June 17, 2002

ULNRC-04674

**DOCKET NUMBER 50-483
CALLAWAY PLANT
UNION ELECTRIC COMPANY
PROPOSED REVISION TO TECHNICAL SPECIFICATIONS 3.9.4
"CONTAINMENT PENETRATIONS"; 3.3.6 "CONTAINMENT PURGE
ISOLATION INSTRUMENTATION"; 3.3.7 "CREVS ACTUATION
INSTRUMENTATION"; AND 3.3.8 "EMERGENCY EXHAUST SYSTEM
ACTUATION INSTRUMENTATION"
TO ALLOW OPEN CONTAINMENT EQUIPMENT HATCH
DURING REFUELING OPERATIONS**

TABLE 16.3-2 (Continued)
ENGINEERED SAFETY FEATURES RESPONSE TIMES⁽¹¹⁾

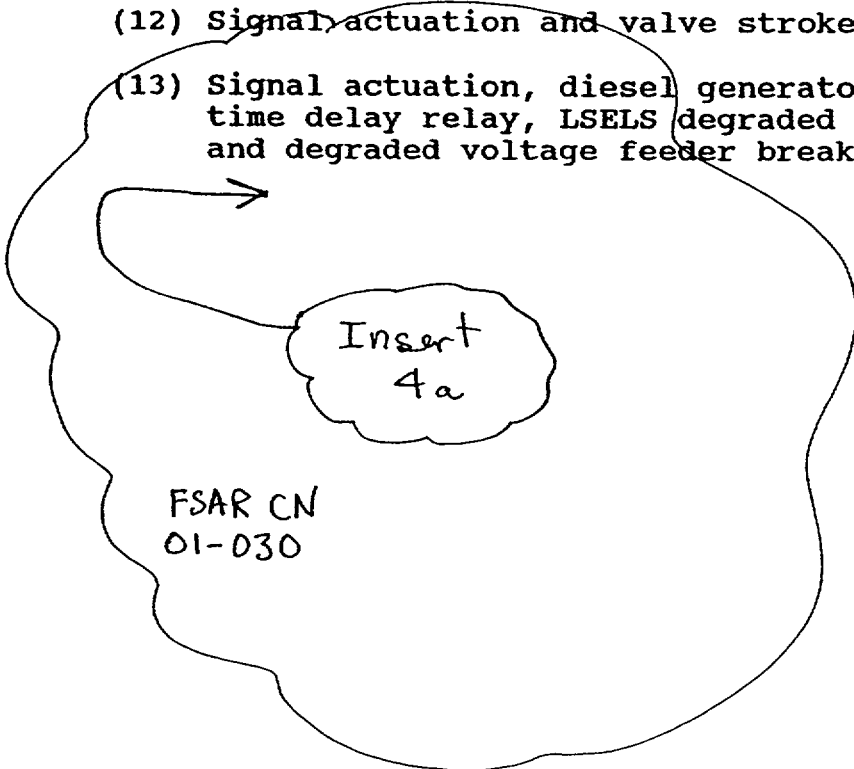
(14) The radiation monitor detector is excluded from response time testing. The stated response time accounts for the elapsed time between introduction of a count rate from the detector corresponding to the actuation setpoint and repositioning of the components necessary to achieve Control Room isolation.
